II. **P22-071:** 50 S. Cache, 45 & 75 E. Pearl - Development Plan

**MINUTES
PLANNING AND ZONING COMMISSION
TOWN OF JACKSON, WYOMING
May 18, 2022**

Meeting Date:	June 1, 2022	Meeting Title:	Planning Commission
Submitting Department:	Planning Department	Presenter:	Tyler Valentine
Agenda Item:	P22-071 Development Plan for a new 3-story, mixed-use building at the properties addressed at 50 S. Cache Street and 45 & 75 E. Pearl Avenue	Public Comment:	No

Project Number	P22-071	Applied	3/30/2022	AL
Project Name	Dev. Plan - 50 S Cache, 45 & 75 E Pearl	Approved		
Type	DEVPLAN	Closed		
Subtype		Expired		
Status	STAFF REVIEW	Status

DRAWING NO
C3.0
JOB NO
21-076-03

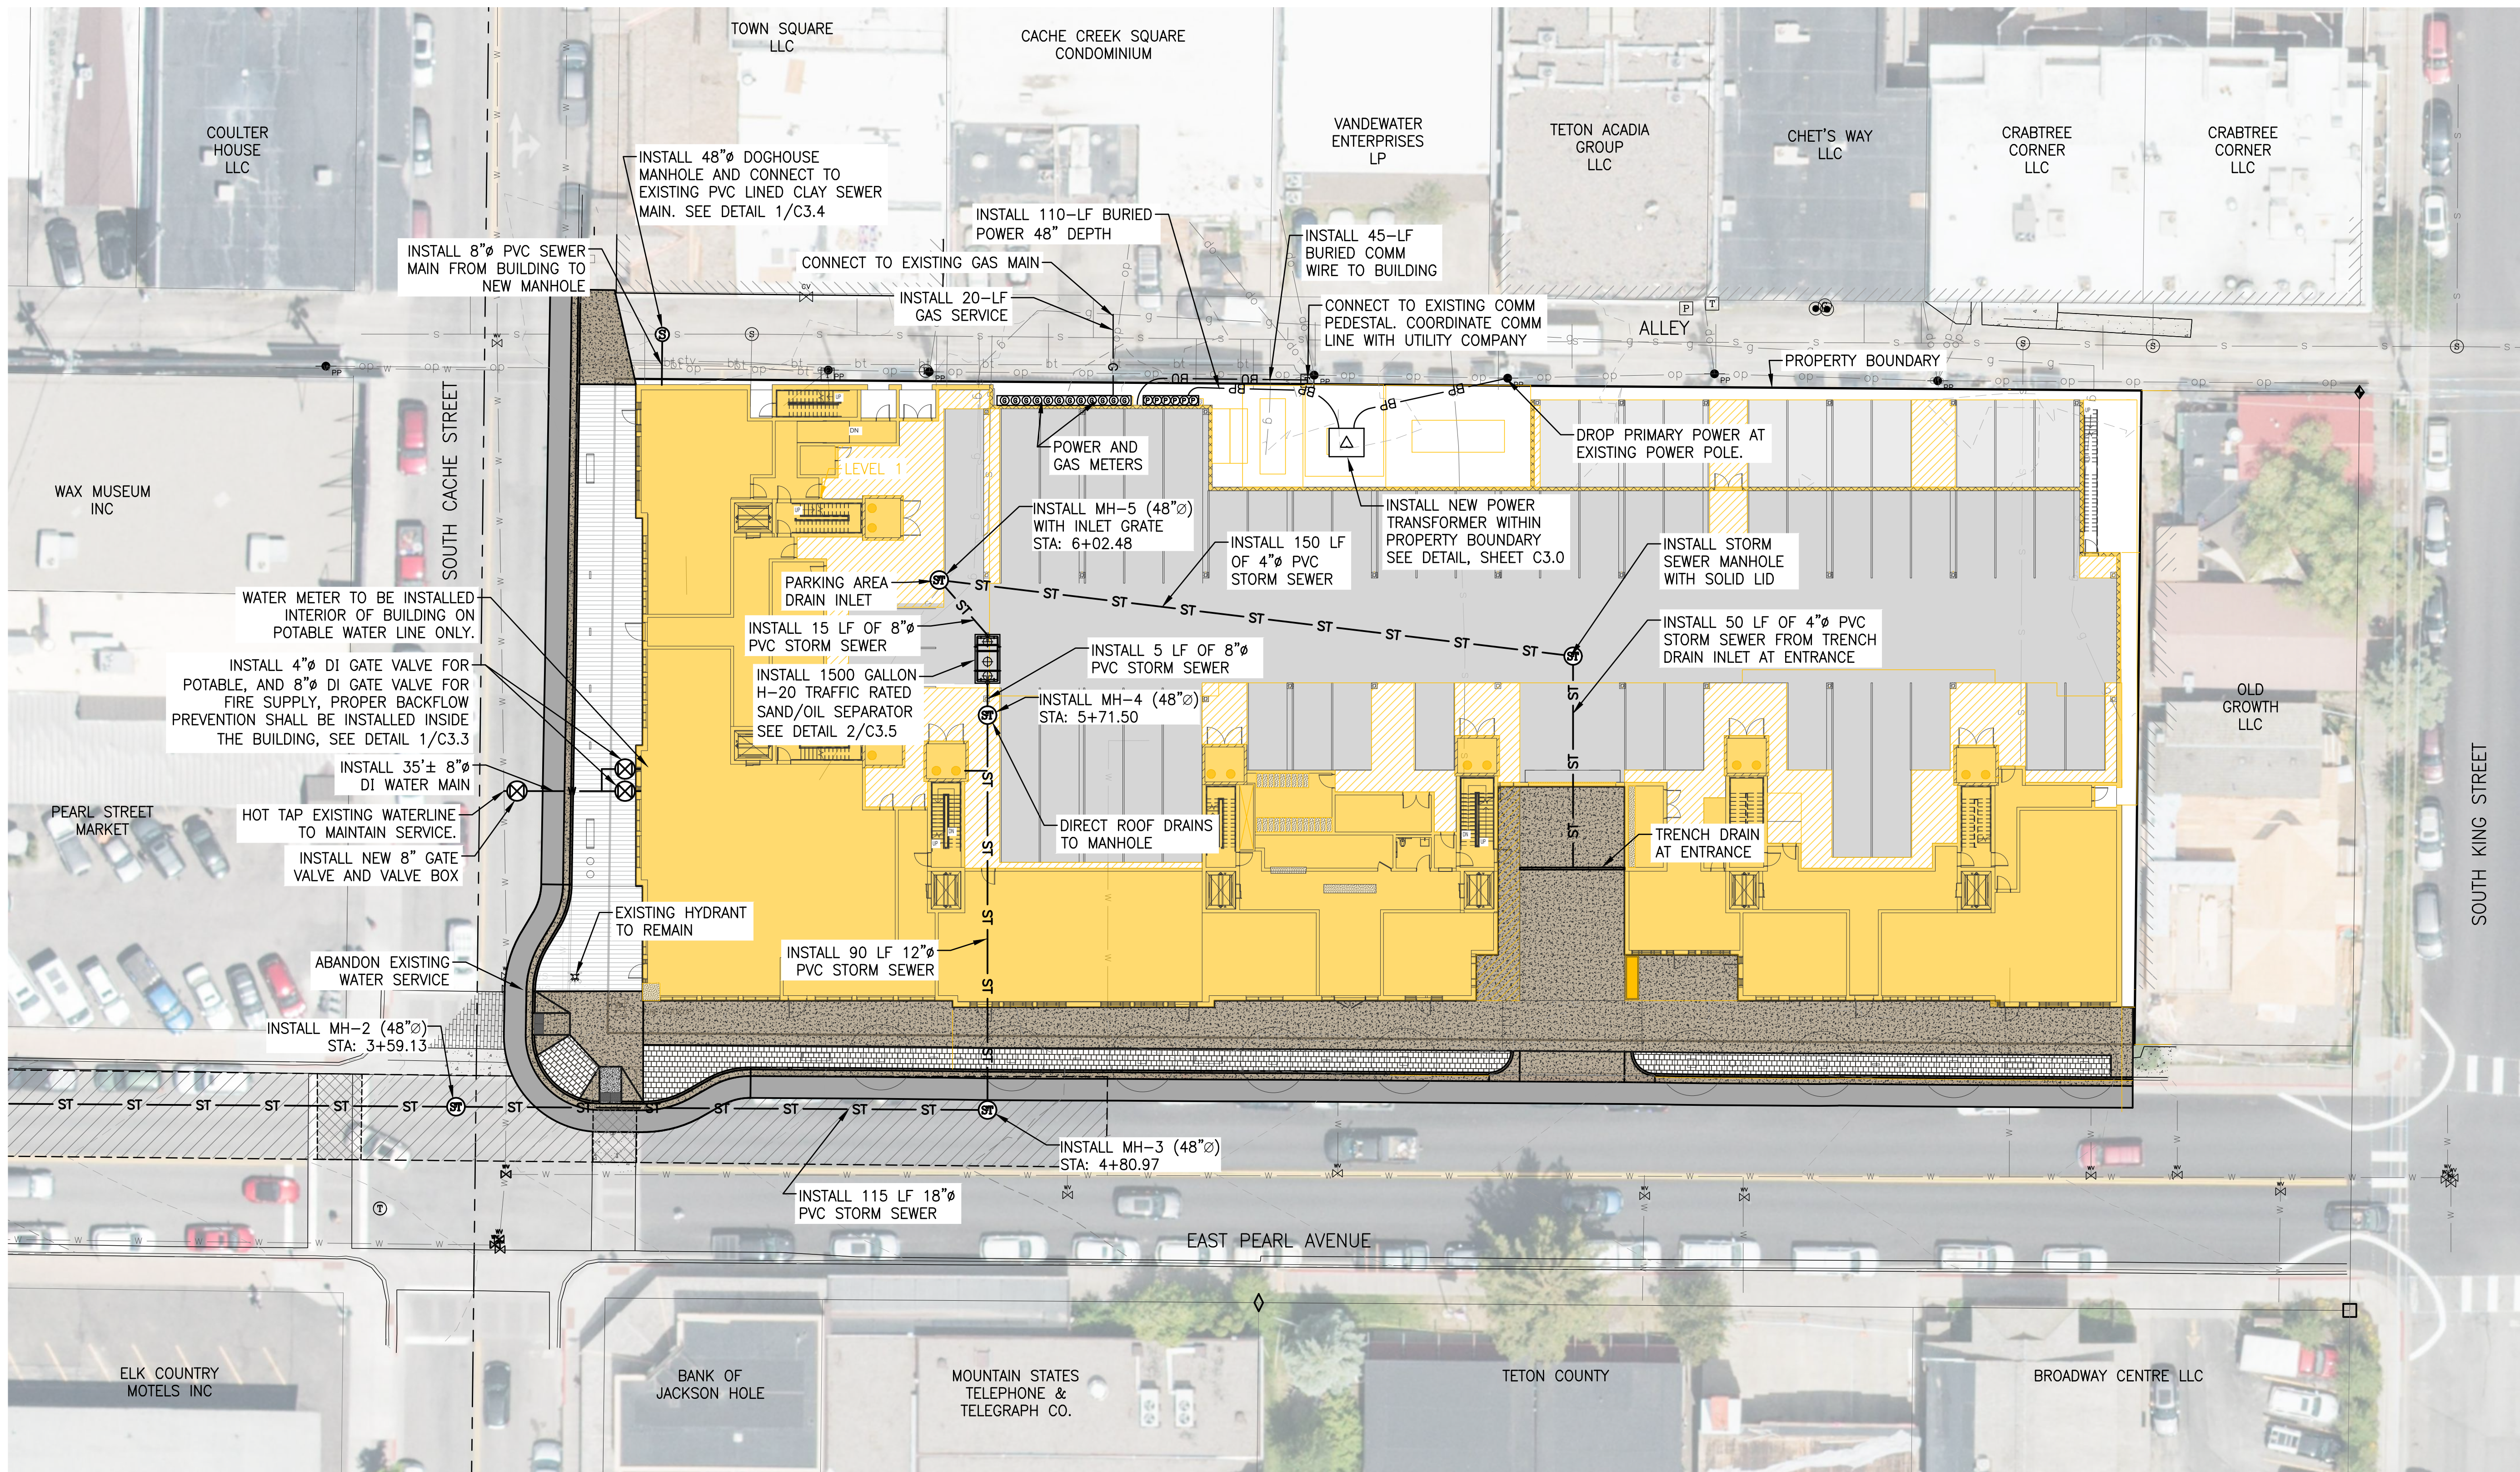
Type of Review	Status	Dates		Remarks
		Sent	Due	
Contact				
Notes				
20. Irrigation plan is unclear with Point of Connections (POC's) shown in relationship to the fire line and domestic water enters the building on Civil Sheet C3.0. Provide a water entry detail including location and size of meters and backflow for domestic, fire, irrigation, etc. Backflow shall be reduced pressure assemblies with drains.

ST-111
C4.3 BOARDWALK DETAIL
TOJ STD DETAIL

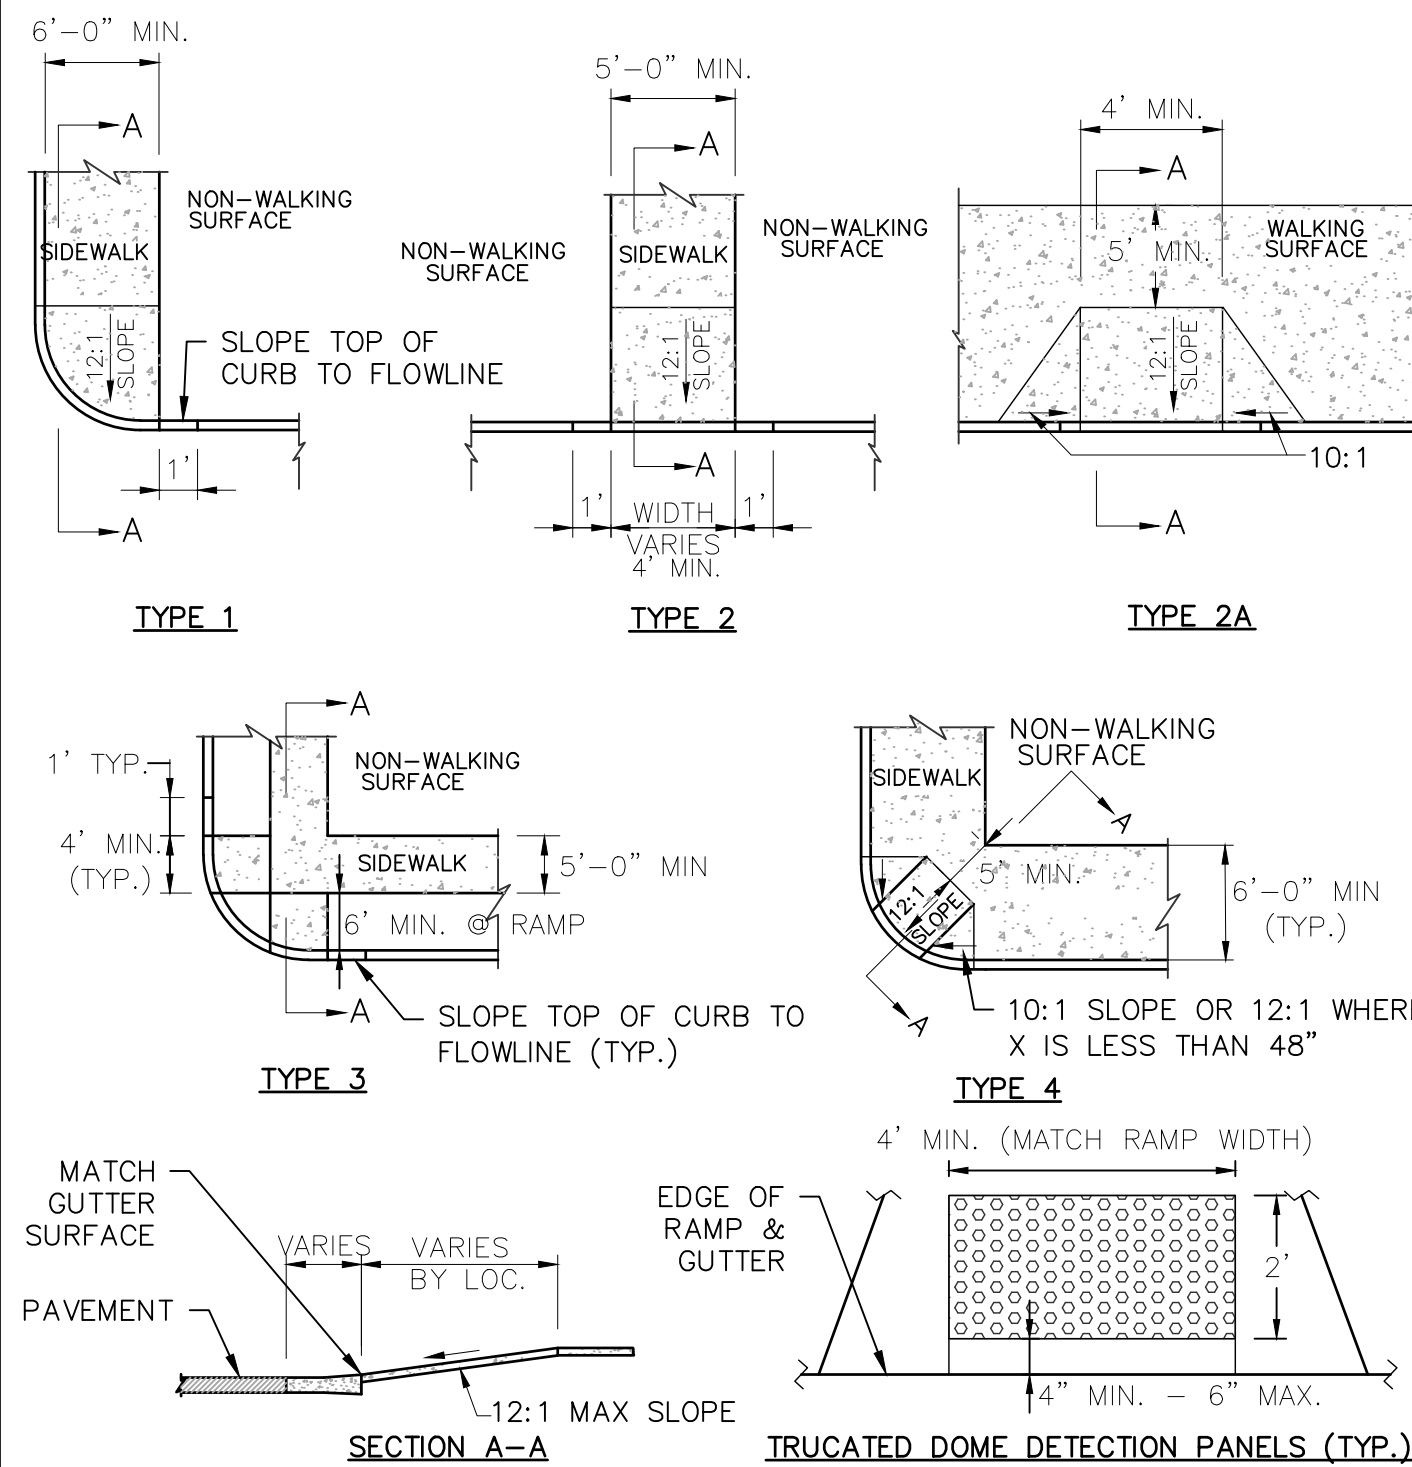
26. Hydronics are not permitted in the Public ROW. SHEET 57 of 160, Detail A, Pedestrian Concrete details snowmelt system w/tubing.				
27. Plans show old boardwalk detail, B. Pedestrian Boardwalk, use rustic boardwalk detail.
